Flight Procedures Cover Page	Task Action: P-NOTAM	Task Type: IAP	Estimated Chart Date: 07/09/2026	APWS Task ID: 751675B8DD61459DA88BC480106AA607	APWS Project ID: 37C828AEF07B429F84E931273512774E
Procedure: RNAV (GPS) Y RWY 26 ORIG-B		Enroute: NO	Specialist: Johnson, Timothy		Agreement Number:
Airport ID: KCMA			Airport City: CAMARILLO		State: CA
Facility ID:	Facility Type:	Flight Inspection Remark Type:

# RNAV (GPS) Y RWY 26

CAMARILLO (CMA)

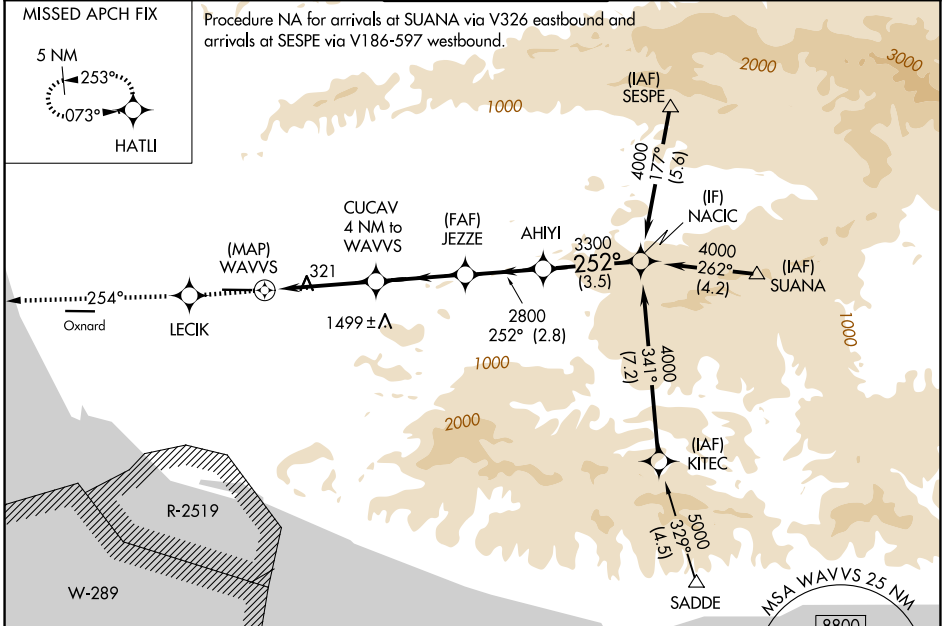
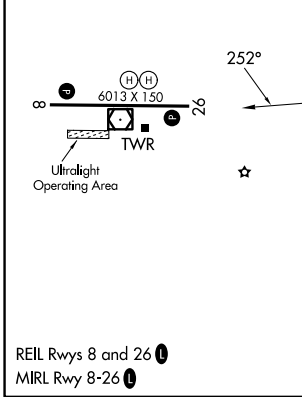
Visibility Initiative (Garmin) - Update IAP visibility minimums IAW Order 8260.3, Chapter 3, Section 3-3. Visibility Minimums.

CATEGORY	A	B	C	D
LNAV MDA	620-1	543 (600-1)	620-1½ 543 (600-1½)	620-1¾ 543 (600-1¾)
CIRCLING	620-1	543 (600-1)	640-1½ 563 (600-1½)	1100-3 1023 (1100-3)
